MC68341

ADDENDUM TO MC68341 Integrated Processor User's Manual

April 19, 1995

Figure 3-12. M68300 Write Cycle timing

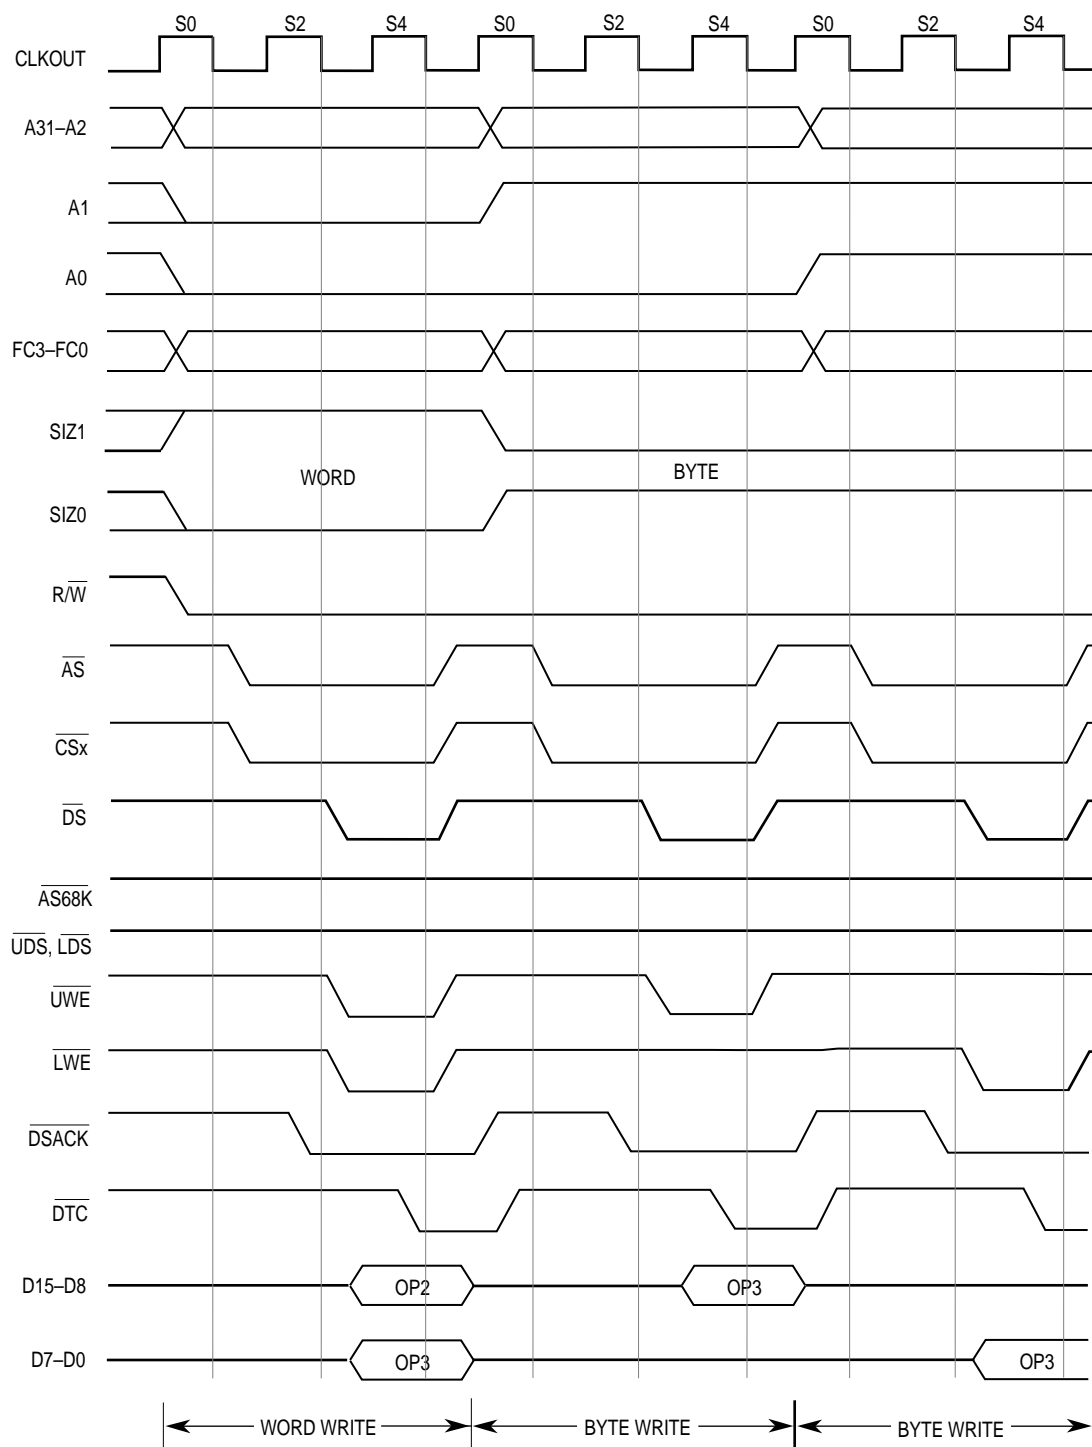
On page 3-25, the M68300 write cycle timing diagram (Figure 3-12) shows incorrect timing for \overline{DS} , \overline{UWE} , and \overline{LWE} . On page 3-28, the M68000 write cycle timing diagram (Figure 3-14) shows incorrect timing for $\overline{AS68K}$, \overline{CSx} , $\overline{UDS/LDS}$, and $\overline{UWE/LWE}$. Replace these figures with the following corrected figures.

Figure 11-2. Sample Crystal Circuit

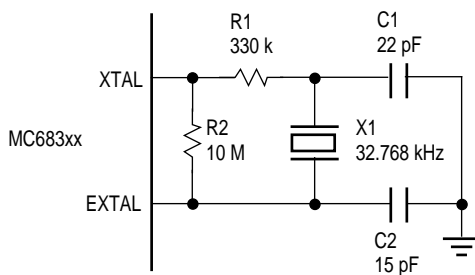
On page 11-2, Figure 11-2, a 10M resistor can be substituted for the 20M R2 bias resistor as shown below.

Figure 11-14. Circuit For Interfacing 8-Bit Device to 16-Bit Memory in Single-Address DMA Mode

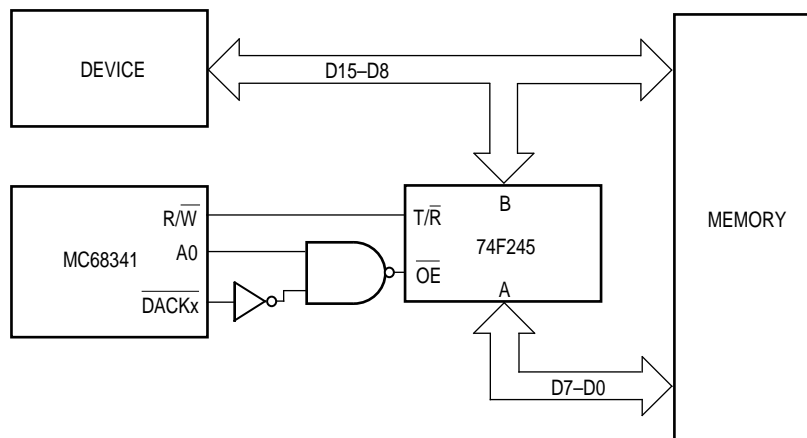
On page 11-10, the logic driving \overline{OE} on the 74F245 in Figure 11-14 should be corrected as shown below. Although not detailed, the byte enables for the memory block should be controlled during reads to prevent contention between the upper and lower bytes of the data bus when D7-D0 is muxed to the upper data byte.

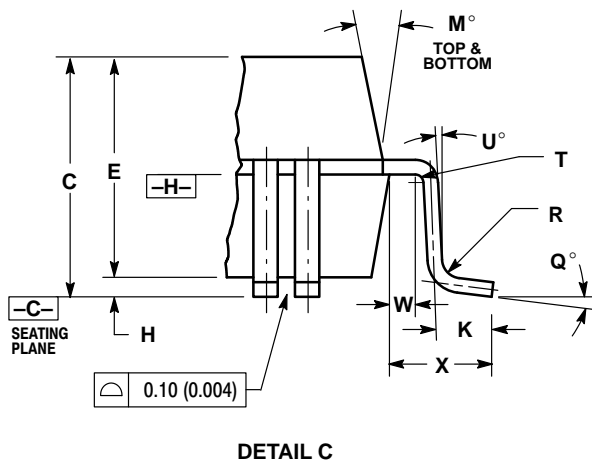
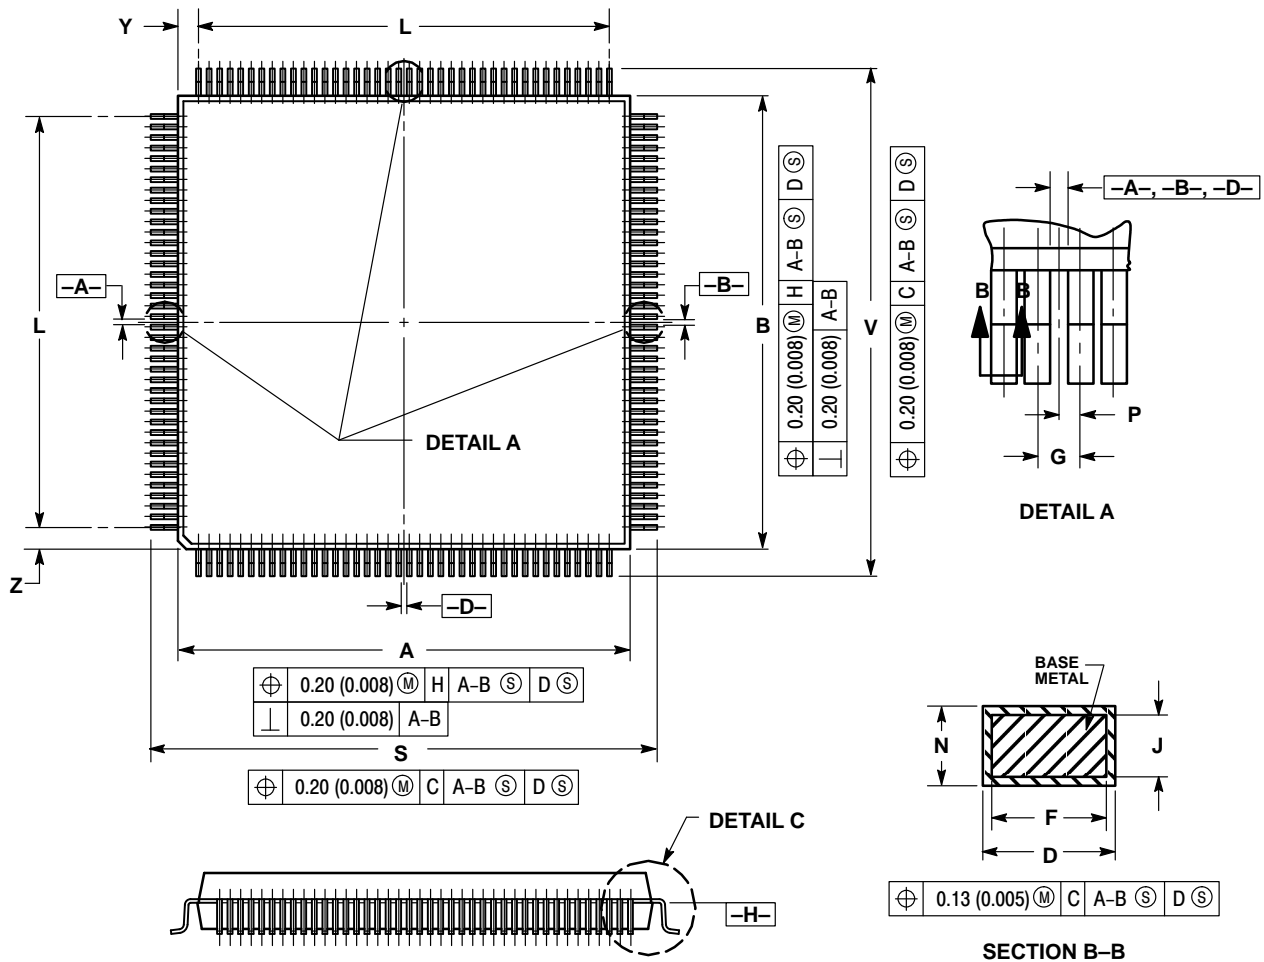
The package dimension drawing on page 13-3 should be discarded and replaced with the following drawing.
